FIELD CHANGE ORDER

Number RQDX3-R001

All MicroVAX, VAXstation II and MicroPDP 1183 systems in BA123 enclosures which contain the 17-00861-01 cable connecting the M7555 to the M9058 will be eligible for this "REQUIRED" FCO.

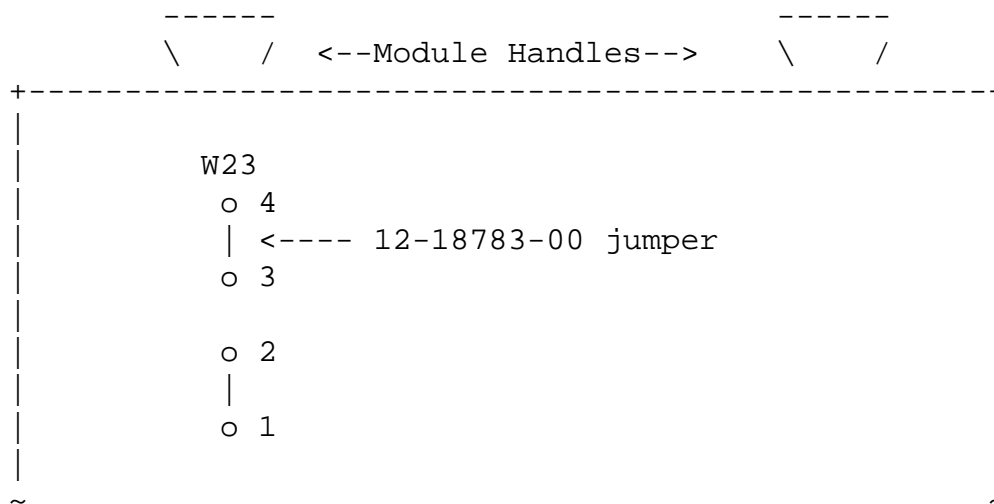
2. Remove the power cord from the power receptacle after powering down.
3. Open the rear door of the BA123 enclosure.
4. Loosen the captive screw that connects the right side panel to the rear of the enclosure frame.
5. The panel is attached to the bottom of the enclosure frame by two snap fasteners. Pull the bottom of the panel out until the panel detaches from the bottom of the enclosure.
6. Lift the panel slightly to release it from the lip at the top of the frame and remove the panel.
